## Model Year 2017, 2018 - US17 Emission Engines -The ( Donaldson ) Fuel Filter - Part Number P550529 - " Cannot " Be Used

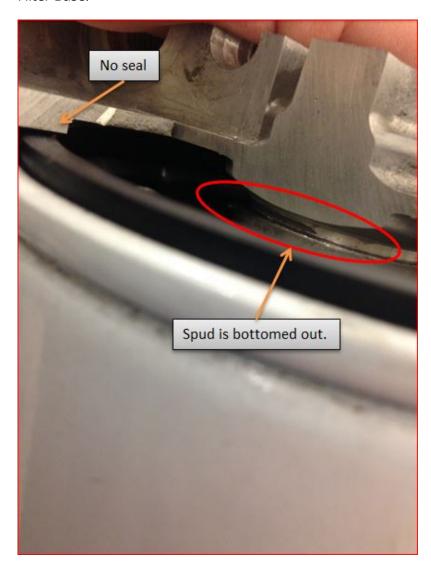
The Donaldson Fuel Filter seal is shown below not contacting the Fuel Filter Base.

For additional information on the correct application Volvo / Mack Fuel Filters refer to CBR solution:

" Fuel Filter Change ( Primary And Secondary ) For The US17 **Emission Engines** "
